Subject: River Bend Station
Docket No. 50-458
License No. NPF-47
Submittal of Proposed Technical Specifications and Additional Information
Related to License Amendment Request (LAR) 99-15, Changes to Technical
Specifications for Power Uprate of River Bend Station

RBEXEC-00-027
RBF1-00-0174
RBG-45471

**PROPOSED TECHNICAL SPECIFICATIONS
ASSOCIATED WITH LAR 99-15**

Figure 3.4.11-1 (page 1 of 1)
Minimum Temperature Required vs. RCS Pressure

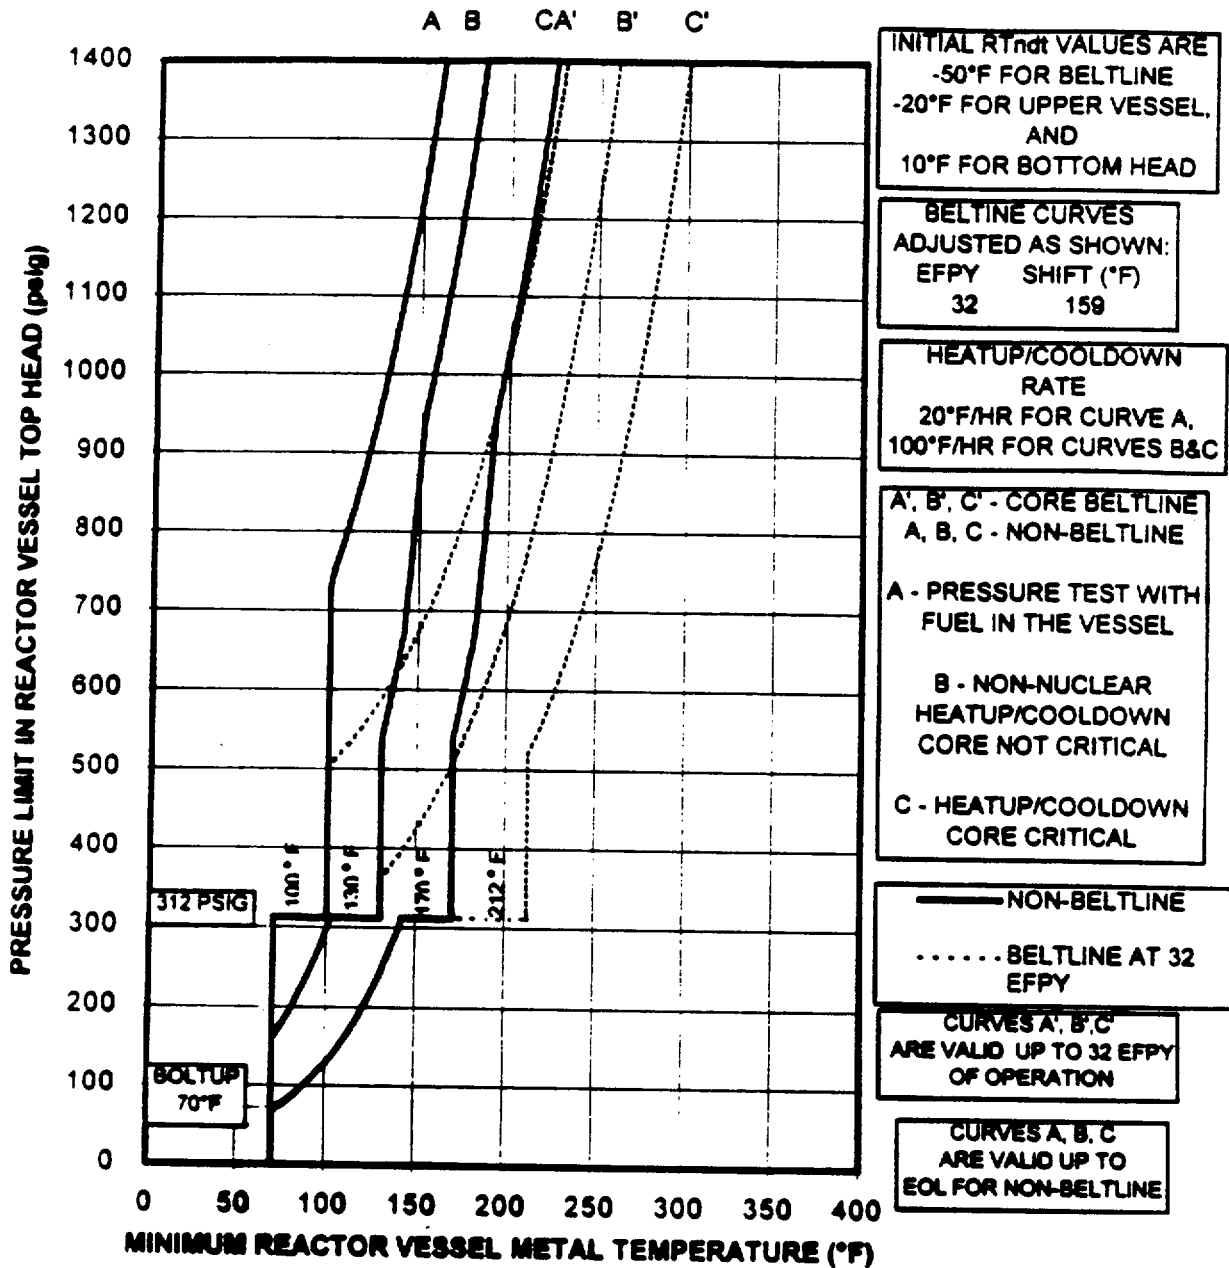
- a. Figure 3.4.11-1 (Minimum Temperature Required vs. RCS Pressure) will be replaced by the Minimum RPV Temperature vs. Reactor Vessel Pressure figure for 32 EFPY only (i.e., the 14 EFPY figure is not included). In addition, the marked-up technical specification pages submitted by the reference (1) letter indicated that this figure was GE proprietary information. Although the GE document (NEDC-32778P) that produced this figure contains proprietary information, the figure itself is not proprietary.
